MAY - 9 2001

Subject: Ground Water Compliance Action Plan for the Grand Junction, Colorado, UMTRA
Project Site

GJO-1999-90-TAR
MAC-GWGRJ 1.9

Ground Water Compliance Action Plan for the Grand Junction, Colorado, UMTRA Project Site

Figure 2. Ground Water Contaminant Plume

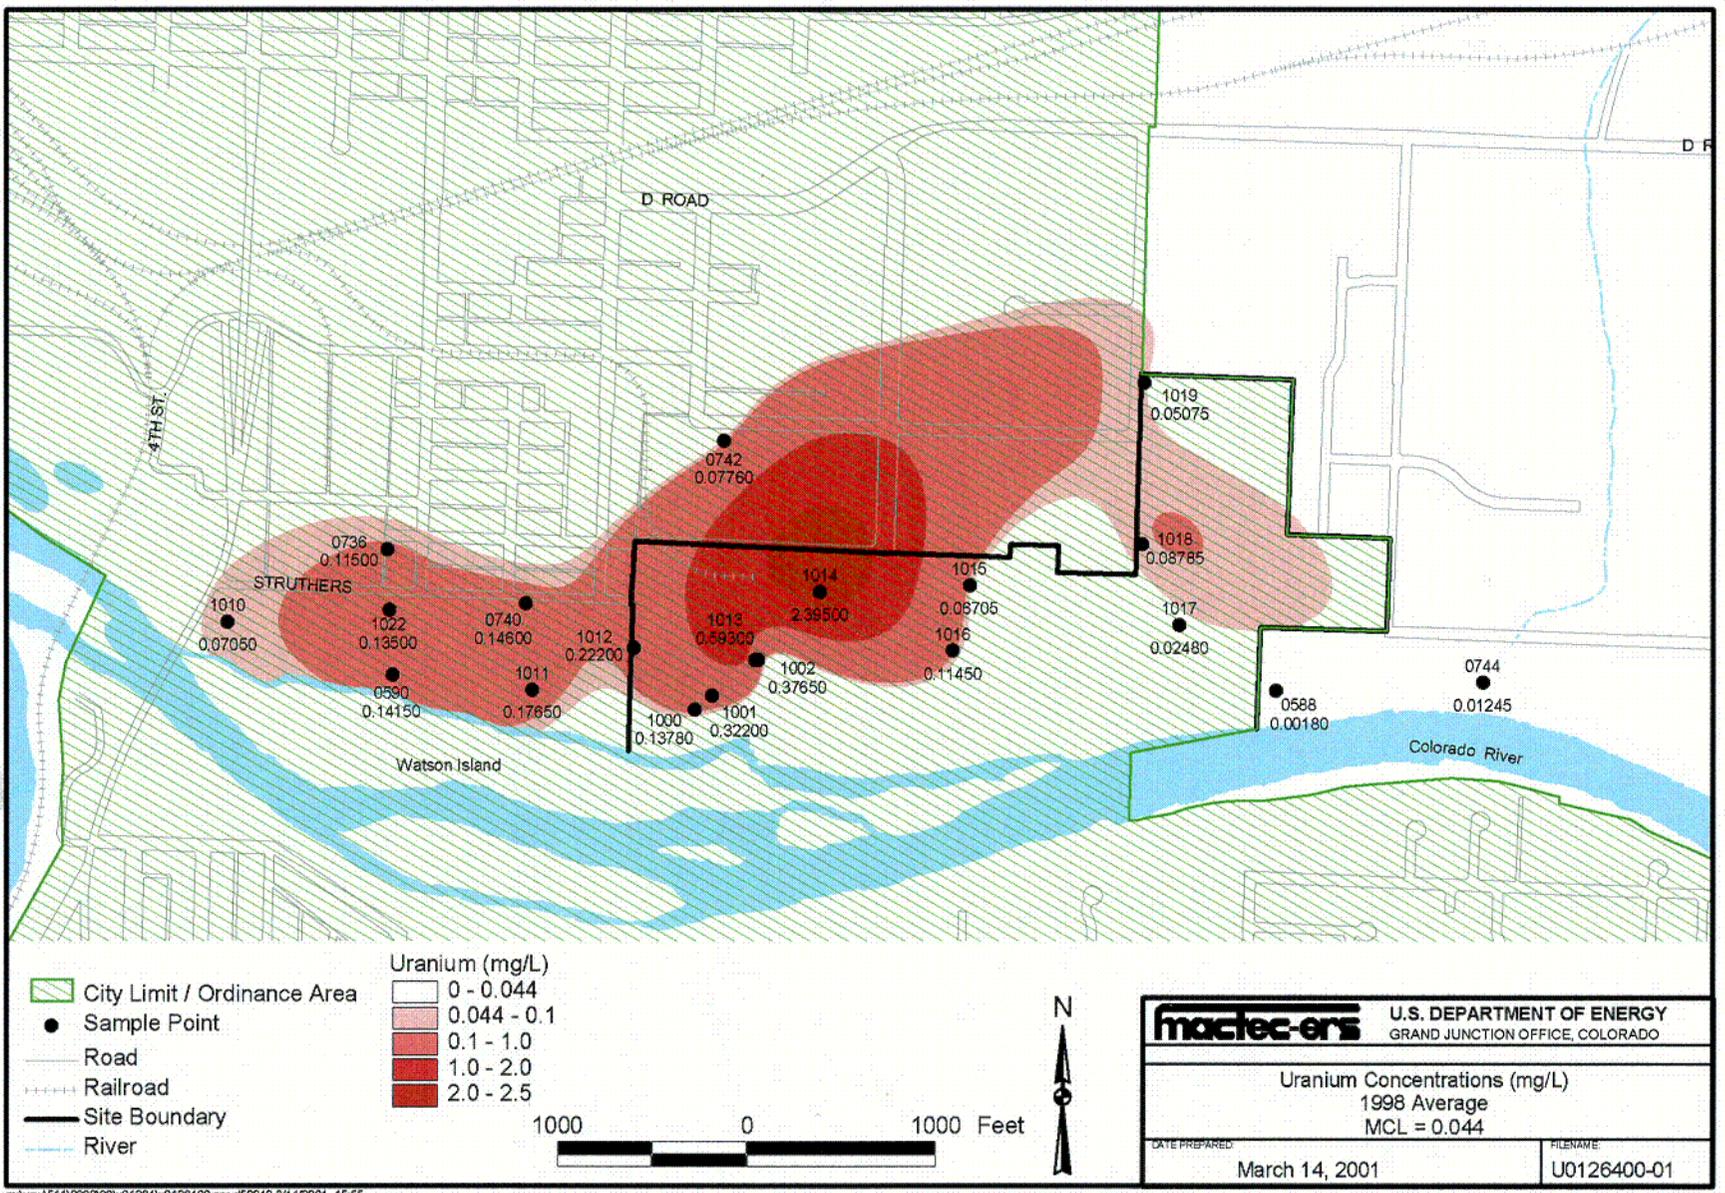
You will find that Section 2.6.1, Institutional Controls, has been expanded to explain the details of off-site controls that were formalized by the City of Grand Junction prior to this study. All residents within this area are required to use municipal water for drinking. Figure 2 was added to reflect this area of influence.

The ground water contaminant plume lies entirely within the city limits (Figure 2). In July 1989, the Grand Junction City Council passed Ordinance 2432 as part of the Grand Junction Zoning and Development Code, which applies to all areas within the city limits. Section 5-4-4 of this Ordinance refers to Potable Water Systems. Paragraph B states "All developments shall be served by the City water treatment and distribution system, unless such requirement is deemed unreasonable or impracticable, as determined by the Utilities Director. All water lines shall be designed to connect to each parcel, as set forth in the previous sentence, with City mains in accordance with applicable engineering standards, unless exempted by the Utilities Manager." Discussions with the Utilities Manager in April 1998 established that city water lines service all potential properties within the ICs boundary thereby eliminating any need to provide relief from the Ordinance.
